from
**Southern
Water**

Our ref
PLAN-034068

Proposal: Demolition of existing house & outbuildings & erection of 1 No dwelling & garage (resubmission following AL/29/20/PL).

Site: AL/51/20/PL: - Tyrone House, Norton Lane, Norton, Aldingbourne PO20 3NH.

Southern Water MapGuide Browser

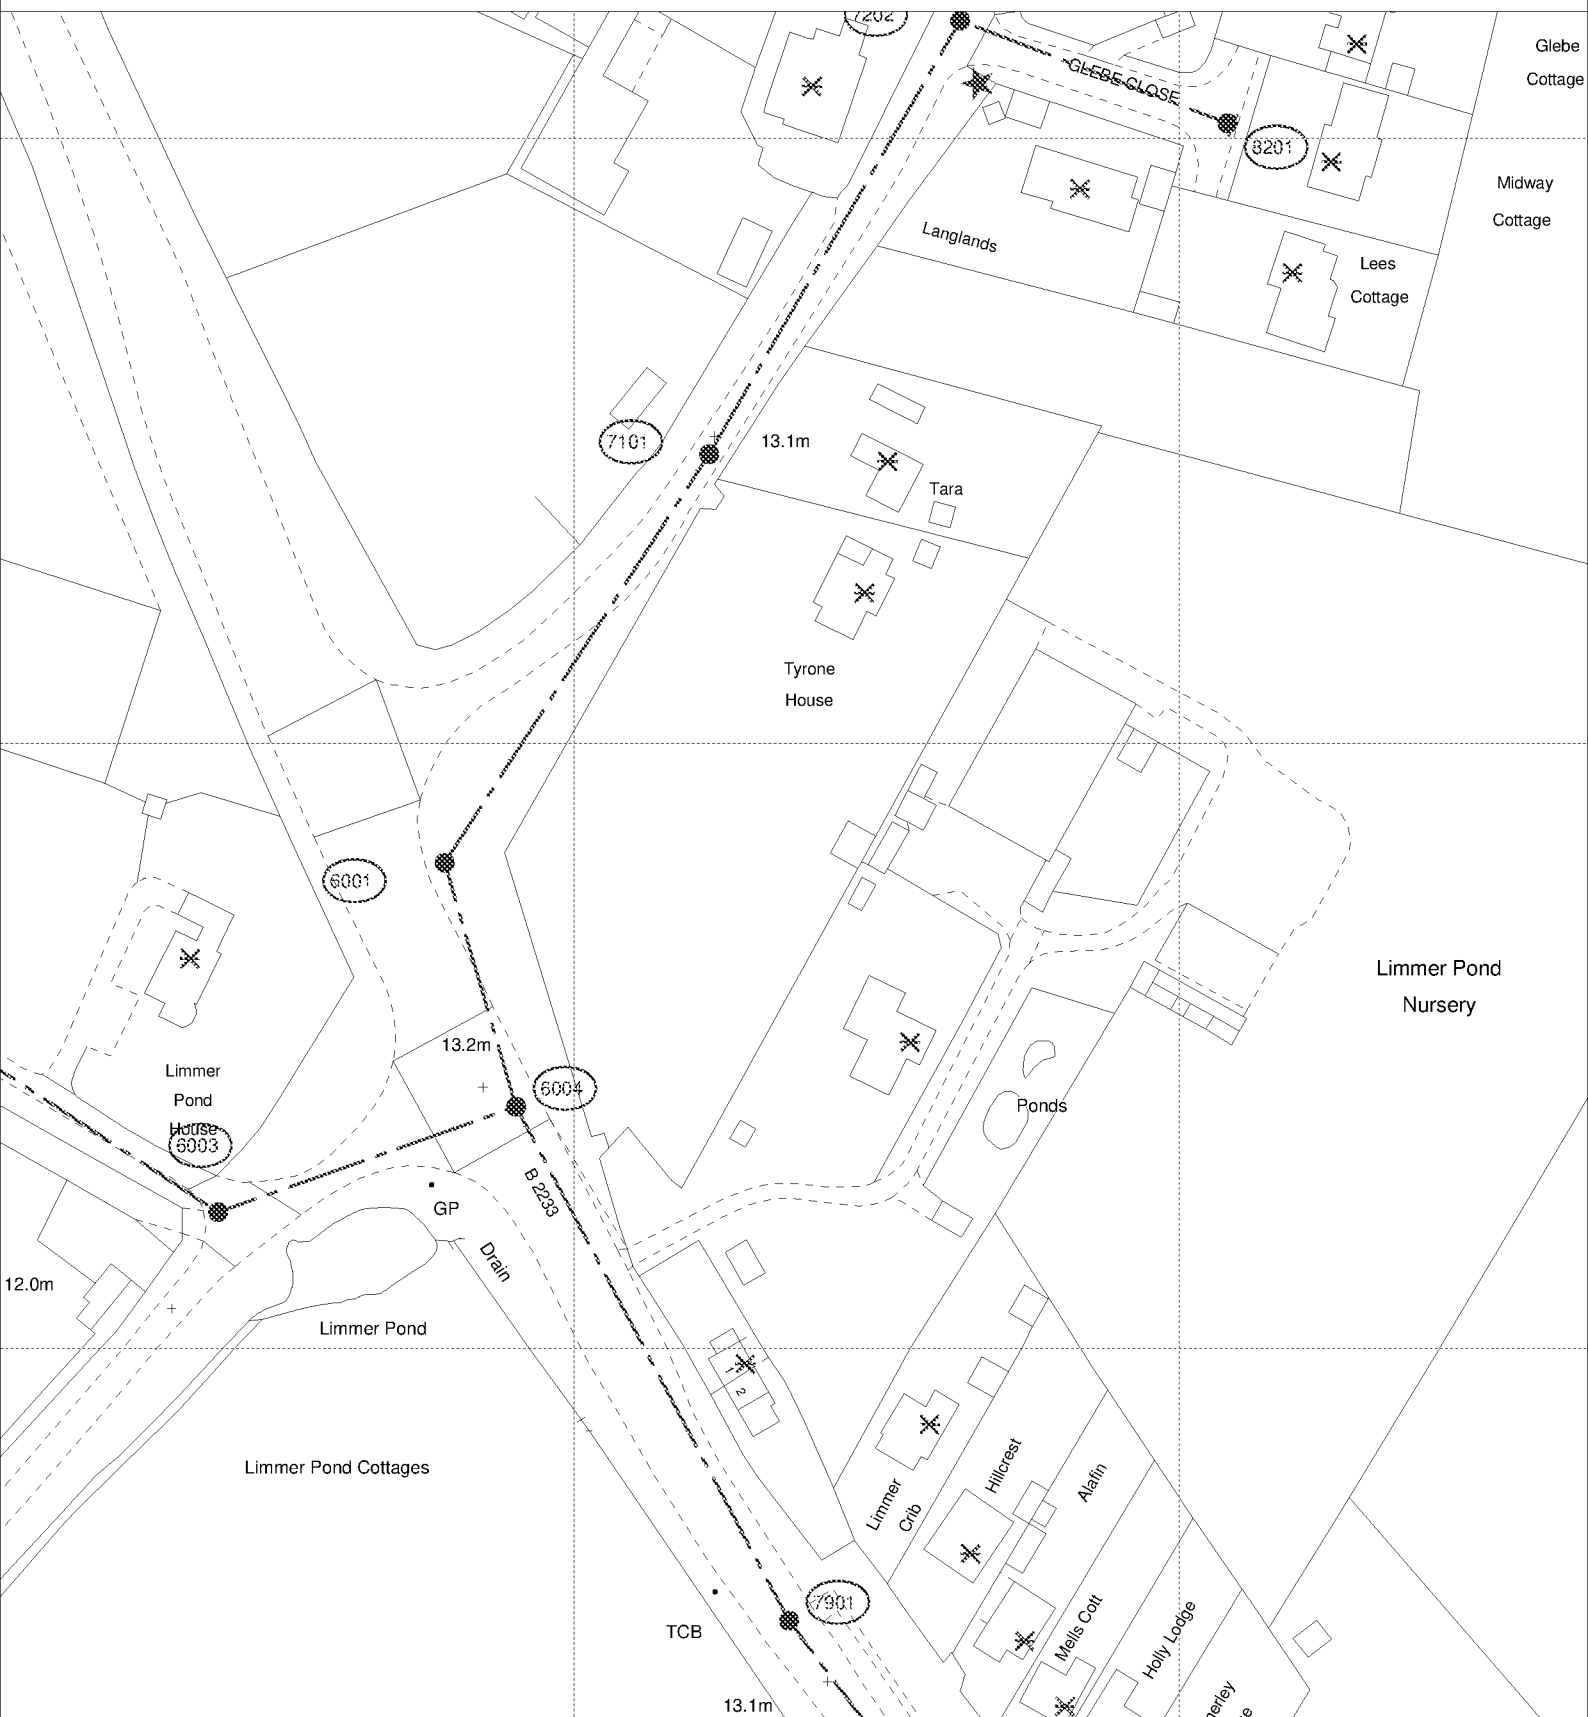
It is possible that a sewer now deemed to be public could be crossing the development site. Therefore, should any sewer be found during construction works, an investigation of the sewer will be required to ascertain its ownership before any further works commence on site.
